UNITED STATES PATENT AND TRADEMARK OFFICE

Office Action Summary	Application No. 10/816,097	Applicant(s) JACKSON, JEFFREY	
	Examiner Tan Le	Art Unit 3632

DETAILED ACTION

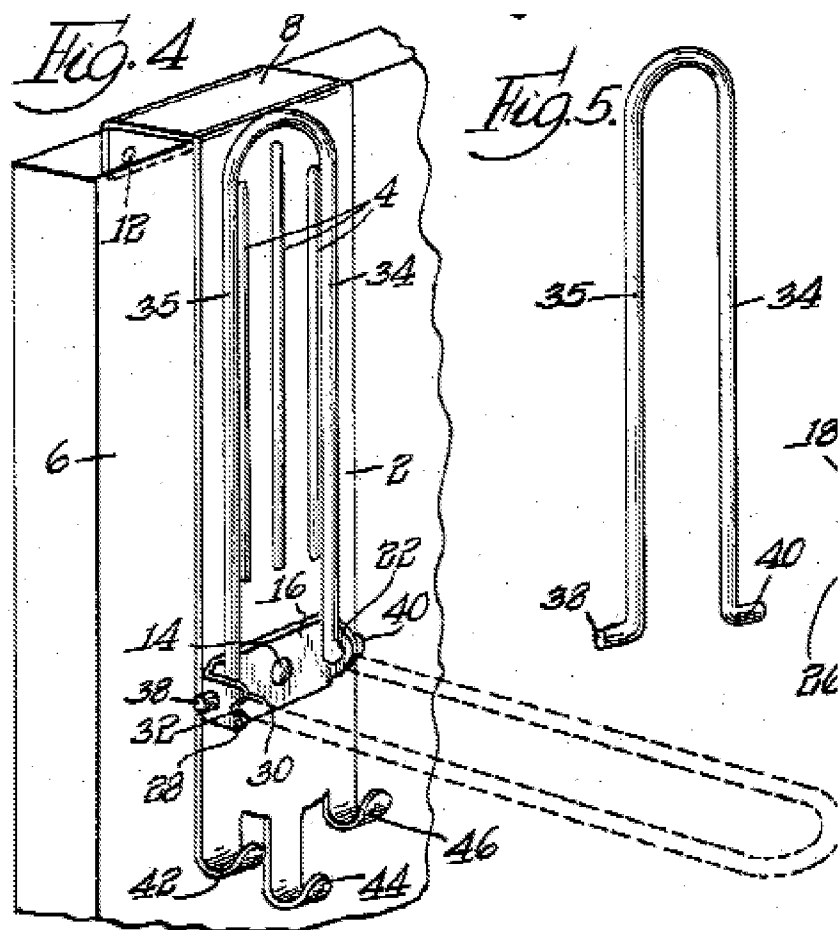
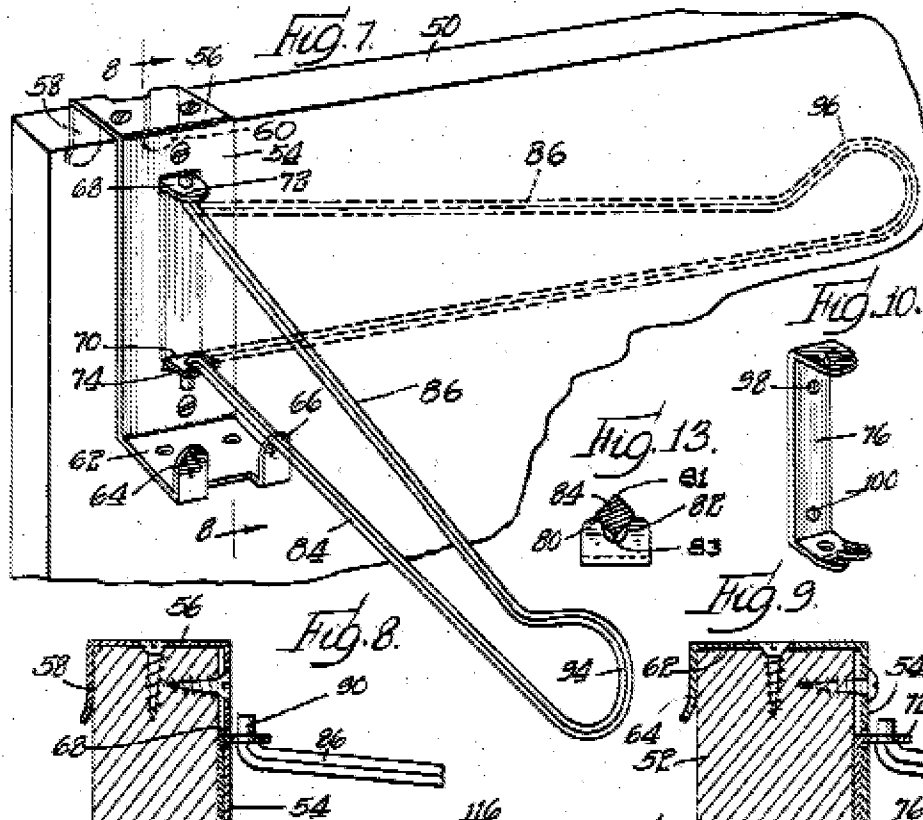
Larson's Figures 1 or 4 also shows a hanger apparatus comprising a holding portion (2, 8) shaped so as to allow said apparatus to hold to said structure by an underside portion (8, 10) (under 8 if orientates vertically as shown on Figs 1 or 4), or under 10 if orientates horizontally) of said holding portion and being capable of resting only on horizontal planar surface said structure (if the structure 6 orientates 90-degree, horizontally); a frictional element (12) affixed to said underside portion and positioned on said holding portion to be in contact only with said horizontal surface (if orientates 90-degree horizontally) whereby said frictional element reduces mobility of said holding portion along said horizontal planar surface; and an enclosed central loop (34, 35) enclosed on top portion, a bottom portion, a front portion, and a back portion of said enclosed central loop, said back portion of said enclosed central loop being a portion of said holding portion, and said enclosed central loop being open on a left side portion and a right side portion of said enclosed central loop; a hook being an extension of said back portion of said enclosed central loop, said hook being capable of allowing said object to be set on said apparatus; wherein said enclosed central loop is capable of allowing a second object to be situated in said central loop after being placed within said left side portion or said right side portion.

As to claim 21, claim 21 is substantially similar to claim 9, is therefore also read on Larson, which includes means for holding (8) to said structure; means for gripping (12) for enhancing the grip of said means for holding on said structure; and means for maintaining a second object in said apparatus (an enclosed loop) (see attached figure), said means for maintaining being enclosed on top portion, a bottom portion, a front portion and a back portion, said back portion of said means for maintaining being a portion of said means for holding, and said means for maintaining being open on a left side portion and a right side portion of said means for maintaining; and means for hanging (hook 44 for example) being capable of allowing a first object to hang from said apparatus, said means for hanging being an extension of said back portion of said means for maintaining a second object in said apparatus, wherein said means for maintaining is capable of allowing said second object to be situated in said means for maintaining after being placed within said left side portion or right side portion.

As to claim 18, wherein said means for hanging extends from said means for holding and wherein said means for hanging is shaped to avoid contact with said structure.

In response to applicant's argument that "Applicant strongly disagrees with this interpretation of the phrase "frictional element", it is believed that this issue is mooted for independent claim 9 by the amendment thereto wherein the frictional element is now required to be "affixed to said underside portion and positioned to be in contact only with said horizontal planar surface", thereby distinguishing over even such a broad interpretation of "frictional element" as when considered to encompass the screws of Larsen. It is therefore believed that this rejection should now be removed for amended claim 9", the examiner disagrees. As pointed out in the office action and as illustrated

on Fig. 4 attached. Larson's projection 12 reads on as the friction element, which is affixed to said underside portion as claimed. Note that Larson's projection 12 presses into the wood to prevent inadvertent removal along not only a horizontal plane but also a vertical plane. This projection 12 is affixed to the underside portion of the holding portion and does a function which considers equivalent to a frictional element function as Applicant claimed. It should also be noted that Applicant's remarks with respect to Figures 7-9 for the limitation "frictional element" is not what Examiner indicated in the office action.
